## ADMINISTRATIVE SHORT PLAT REPORT & DECISION

<b>REPORT DATE:</b>	March 31, 2015
<b>Project Name:</b>	Skagen 5-Lot Short Plat
<b>Project Number:</b>	LUA15-000024, SHPL-A
<b>Project Manager:</b>	Clark H. Close, Associate Planner
<b>Owner/Applicant:</b>	Michael & Laura Skagen, 12050 SE 178 <sup>th</sup> St, Renton, WA 98058
<b>Contact:</b>	Phillip Kitzes, PK Enterprises, 23055 SE 263rd St, Maple Valley, WA 98038
<b>Project Location:</b>	197XX Talbot Road South (APN 793100-0058), Renton, WA 98055
<b>Project Summary:</b>	The applicant is requesting approval of a 5-lot short plat for the future development of 5 single-family houses. The subject property is located on Talbot Rd S, between S 196th Pl and S 199th St in the Residential-4 dwelling units per acre (R-4) zone. The applicant is requesting the clustering of 5 lots with two open space tracts, Tracts A and B, to be used to satisfy the 30% open space requirements. The proposed lots range in size from 7,005 gross square feet in area to 7,020 gross square feet. The residential density is 4.4 dwelling units per net acre. Access to the lots would be from Talbot Road S. Half street frontage improvements will be completed along Talbot R

**SKAGEN 5 LOT SHORT PLAY  
CITY OF RENTON  
WASHINGTON  
LANDSCAPE PLAN**

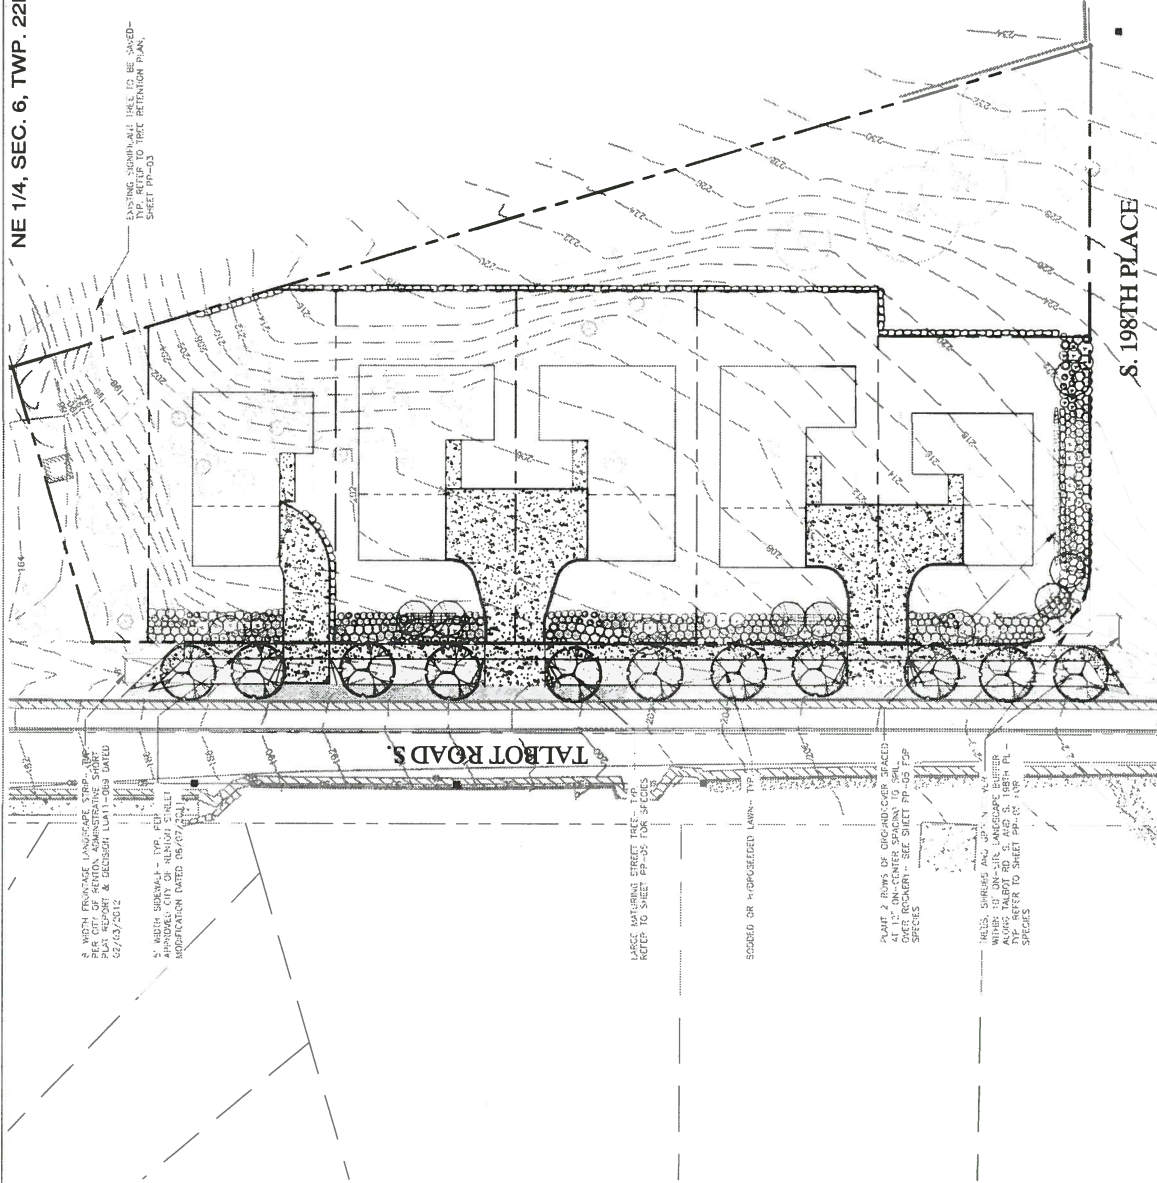
<b>Engineering Review Comments</b>	<b>Kamran Yazdidoost   425-430-7382   kyazdidoost@rentonwa.gov</b>
Recommendations: Rock wall cannot be at planter strip area. Please remove the rock wall from planter strip area (sheet 6 of 13). Please replace the note at rock wall detail to "handrail required when the rock wall is over 2' 6" from height measured from ground.

C. Street trees: Street trees shall be spaced 50 feet on-center or further' use only 6 trees along Talbot. No street tree shall be closer than 30 feet from a street light (not shown on plans). No street tree shall be closer than 6 feet to a fire hydrant. No street tree closer than 10 feet to a driveway approach.

Sidewalk and Planting Strip – On north end bring sidewalk and planter strip up to property line. Plan shows it stopping about 10 feet short.

4. The applicant shall move all retaining walls at least three (3) feet behind the public right-of-way. A revised landscaping plan shall be submitted to, and approved by, the Current Planning Project Manager prior to construction permit approval.
